RE: CBRM T31-2022 – GLACE BAY WASTEWATER COLLECTION PROJECT

**CAPE BRETON REGIONAL MUNICIPALITY
Glace Bay Wastewater Collection Project**

Tender # T31-2022

Addendum No. 1

.1 Please add Figure 1 – Combination Air/Vacuum Release Chamber to the Standard Details.

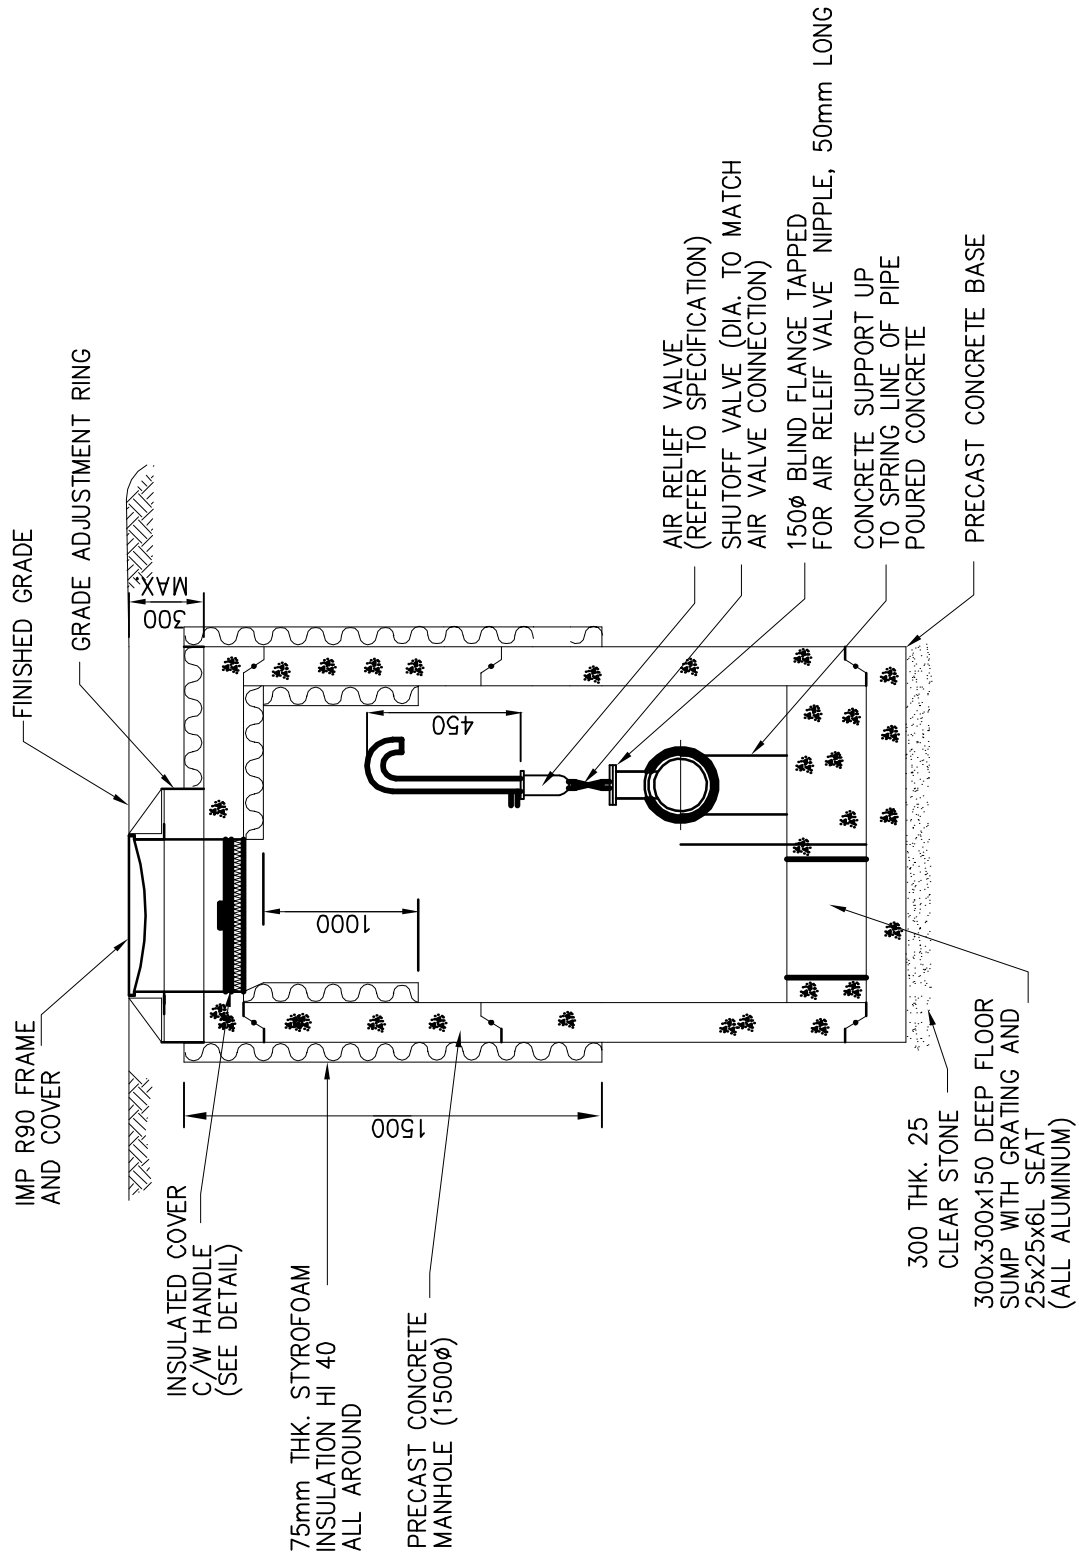
NOTE
TRANSITION TO DUCTILE IRON PIPING 450mm OUTSIDE OF AIR CHAMBER
